**RE: DEVELOPMENT PERMIT FOR A MATERIAL CHANGE OF USE FOR
A MULTIPLE DWELLING**

**212 – 220 SHAFSTON AVENUE, KANGAROO POINT QLD 4169
AND DESCRIBED AS LOT 1 ON RP117044 AND LOT 0 ON BUP670
RESPONSE TO COUNCIL INFORMATION REQUEST (APPLICATION
REFERENCE: A007021113)**

Figure 1: Proposed verge widening and bike path easement allowance

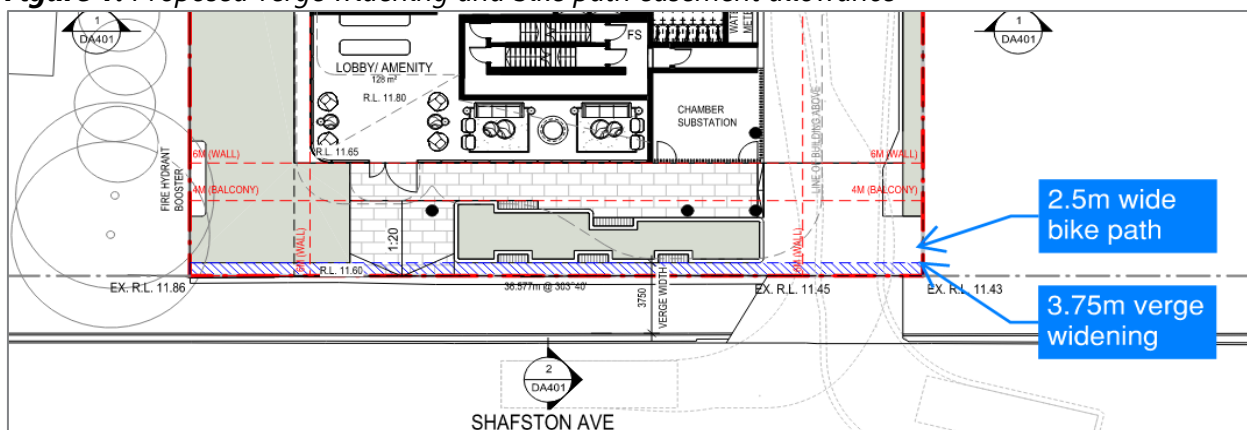
- Provide amended plans illustrating a volumetric public thoroughfare easement in favour of Council along the frontage of the site. It is considered that a volumetric easement width 2.5m and a length of 12.5m would allow for a sufficient area for pedestrian respite and embellishments to be provided in this area such as a bench seating, low-level planting, or the like. Please note that this item is to be read in conjunction with Item 2) of the information request which requests a linear dedication to achieve a 3.75m wide verge.
- Illustrate on the proposed plans embellishments and improvements to this area that will complement the bikeway project, such as drinking fountains, bench seating, or the like, providing a respite area for users of the bikeway.

The architectural plans have been amended to provide for a volumetric public thoroughfare easement measuring 2.5m wide by 12.5m long along the Shafston Avenue frontage. This spatial allowance is provided in addition to the 3.75m verge. The proposed easement is identified on the amended architectural plans included at **Attachment A**. The below figure illustrates the intended verge and easement arrangements.

Figure 4: Revised pedestrian sight splay

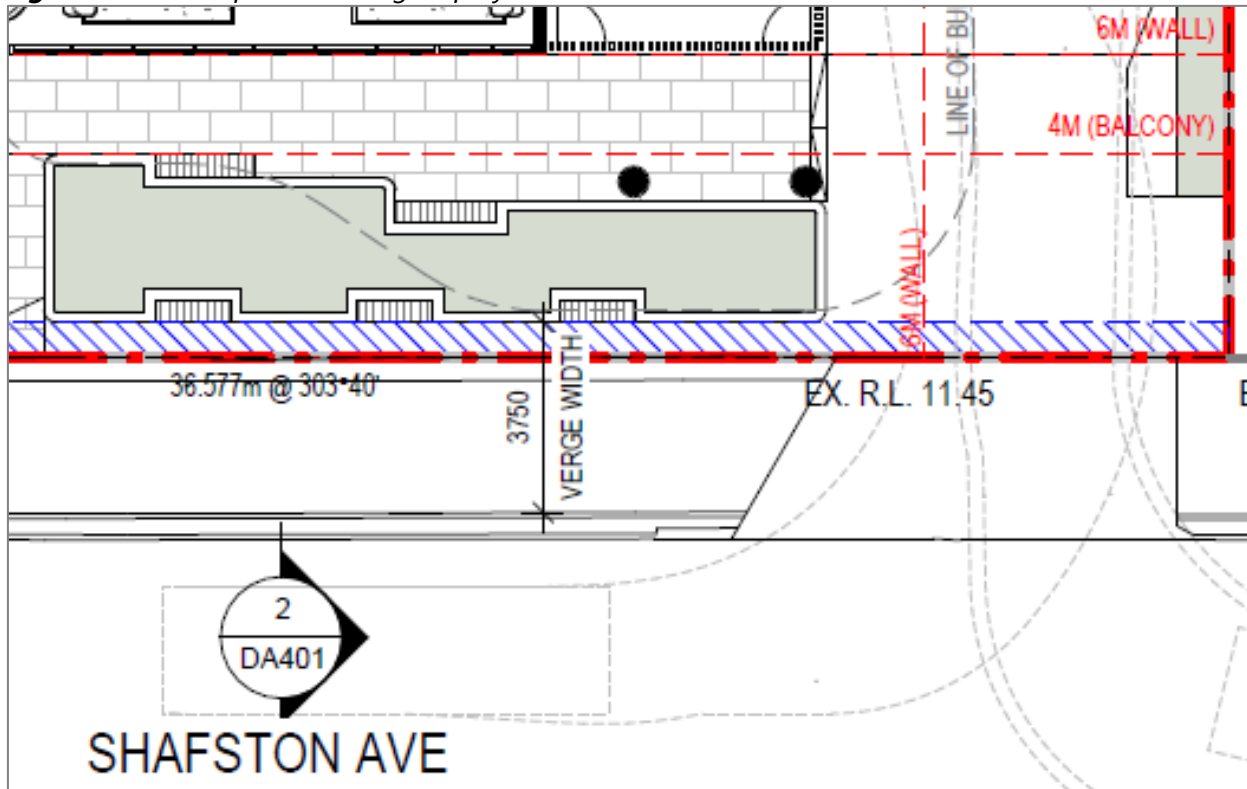
Ensure the proposed pedestrian sight splay is contained wholly within the subject site, currently located on the eastern boundary of the proposed ground floor plan

The architectural plans have been amended to ensure that the required pedestrian sight splay is located wholly within the subject site.

The amended sight splay is shown adjacent to the Shafston Avenue driveway entrance and is clear of structures, landscaping and other potential visual obstructions. The below figure illustrates the revised pedestrian sight splay.

Figure 5: Level 5 floor plan showing location of harness anchor points for maintenance

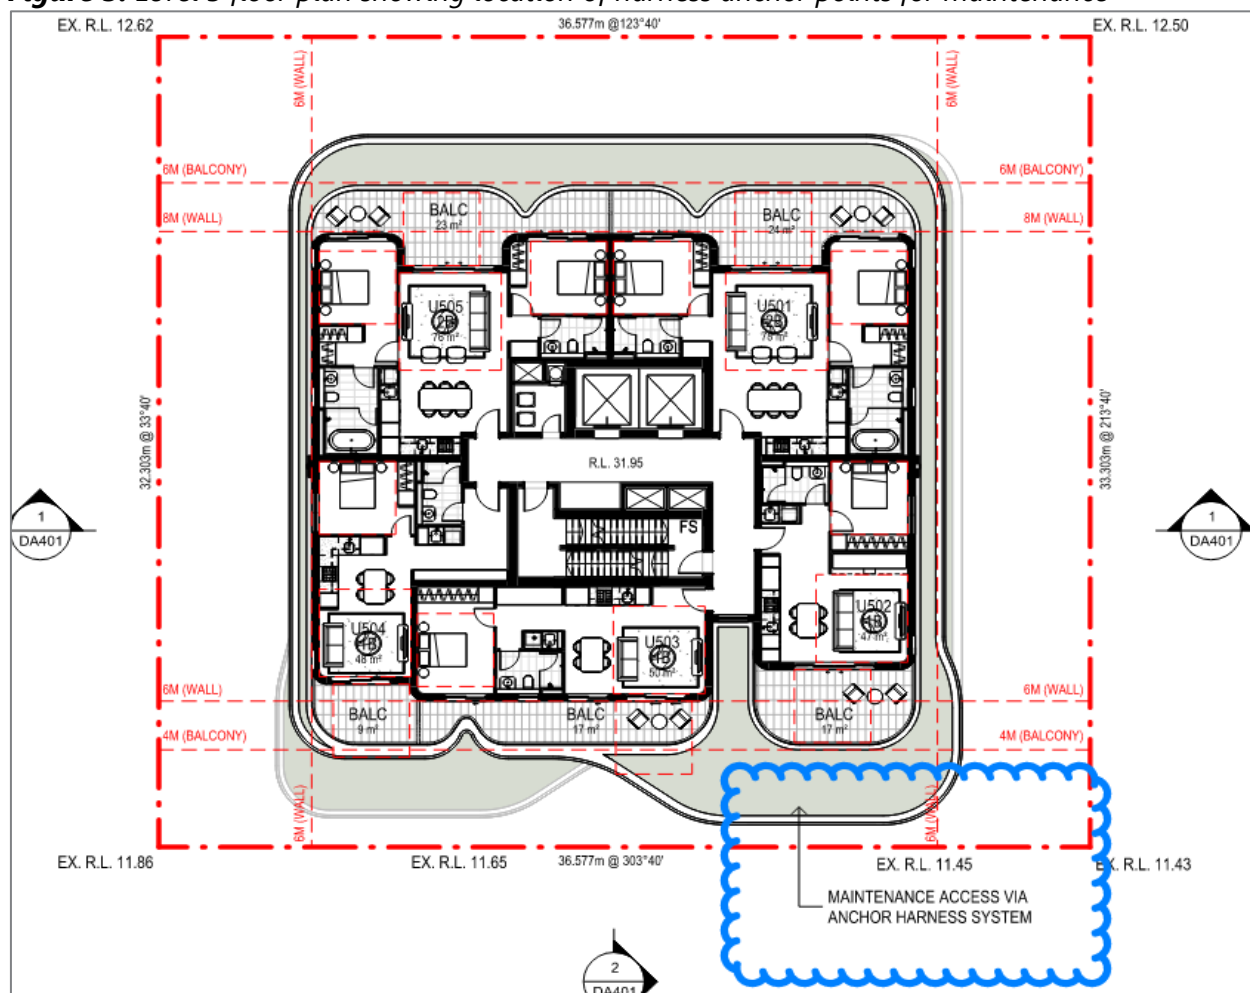
- (a) In accordance with PO4, PO13 and PO15 of the Landscape work code, the SBDPSP and the LDPSP, submit amended plans demonstrating safe and practical access to all containerised planters for ongoing landscape sustainability and maintenance.
- (b) In accordance with PO12, PO13 and PO15 of the Landscape work code and the LDPSP, submit additional plans and information detailing the following information:
 - (i) Irrigation application rates ($L/m^2/week$) prepared by a suitably qualified irrigation designer accredited by the Irrigation Association of Australia (Diploma of Irrigation or equivalent);
 - (ii) Stormwater harvesting capacity and water storage requirements for landscape irrigation; and
 - (iii) The dimensions, capacity and location of all water storage devices.

A certified fall-arrest and restraint system, comprising appropriately located harness anchor points, is proposed at Level 5 to facilitate safe access to landscape areas where direct maintenance access is constrained. The system will be designed, certified and installed in accordance with the relevant Australian Standards and workplace health and safety requirements.

The location of the proposed harness anchor points is shown in Figure 5 and on the amended Level 5 floor plan.

Figure 8: Eastern boundary landscape screening and relationship to adjoining property

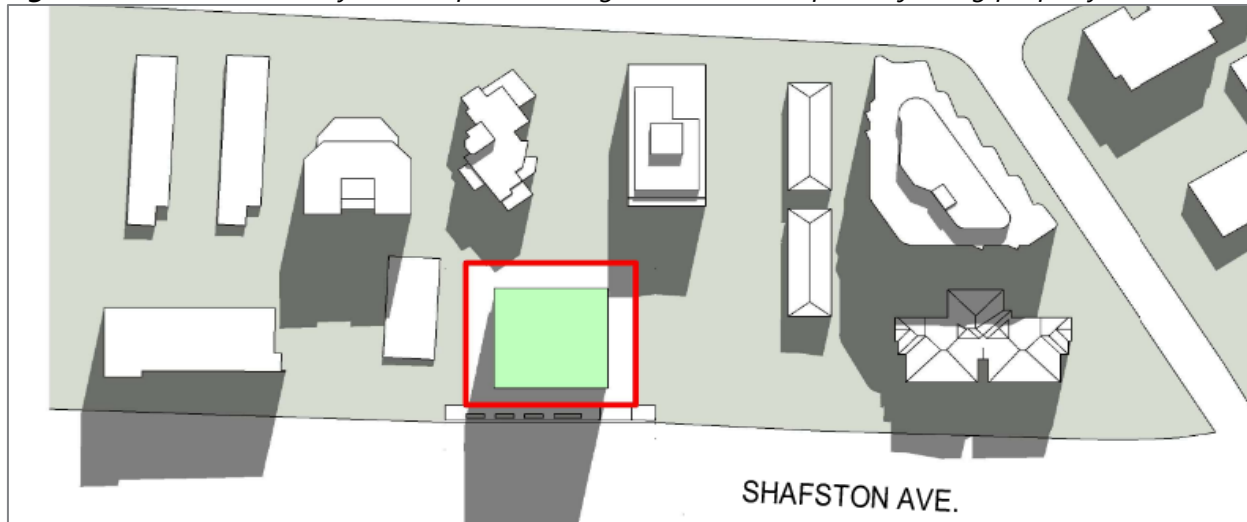
- Provide amended plans illustrating side boundary planting densities, species and stock sizes to moderate the visual amenity impacts of the driveway and basement ramp.*
- Provide indicative cross-sections to neighbouring properties illustrating landscaping screening.*

The landscape design has been amended to provide continuous screen planting within a 1.0 m wide landscape strip along the eastern side boundary, including adjacent to the driveway and basement ramp. The proposed screening will comprise tall, columnar trees planted for the full length of the boundary, with the following indicative specifications:

- Species: *Syzygium smithii* or a similar suitable screening species;
- Stock size: 45L to 100L;
- Spacing: approximately 1.5 m centres; and
- Purpose: to provide a dense vertical landscape screen that moderates views of the driveway and basement ramp from the adjoining property.

Additional cross-sections demonstrate that the proposed planting can be accommodated within the available landscape strip and will provide effective screening as the vegetation establishes and matures. The relationship between the proposed development and adjoining properties to the east is illustrated in **Figure 8**.

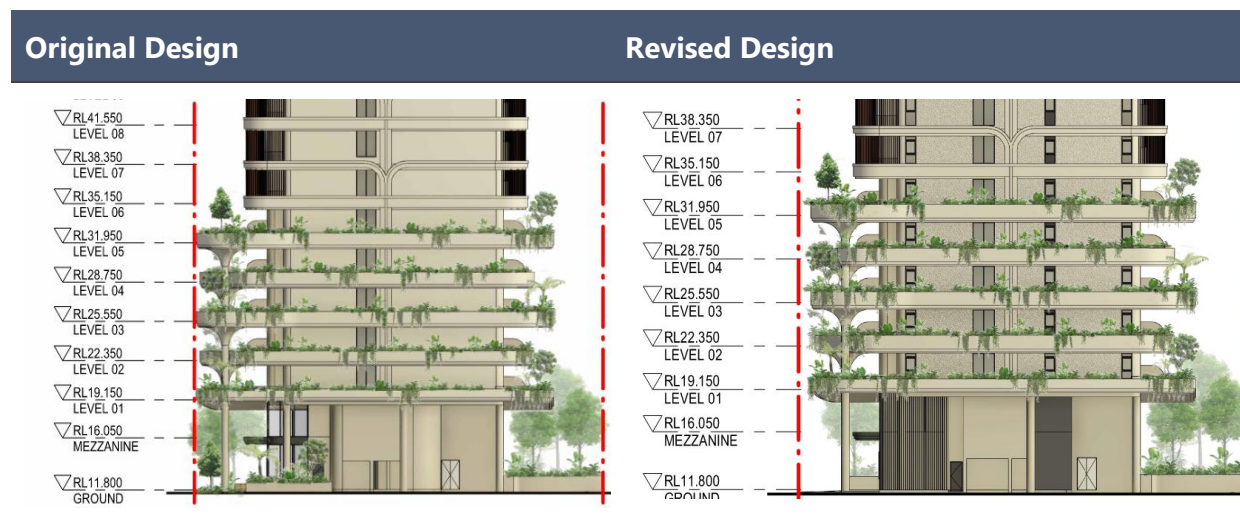
The proposal presents a well-articulated façade and building renders indicate a high-quality residential design outcome. To demonstrate the development achieves true climatically responsive building design, further consideration is to be given to providing windows within the wet areas along the western and eastern facades to assist in providing good opportunities for access to light and cross-ventilation to reduce the need for mechanical ventilation, cooling and lighting, in accordance with PO26 of the Multiple dwelling code.

Additional window openings have been incorporated into the wet areas along the eastern and western façades. These openings improve access to natural light and ventilation, reducing reliance on mechanical ventilation and artificial lighting.

The additional windows also improve the articulation and visual interest of the eastern and western façades. The revised architectural plans therefore provide a more climatically responsive design consistent with PO26 of the Multiple dwelling code. Comparison between the original and revised design is provided below.
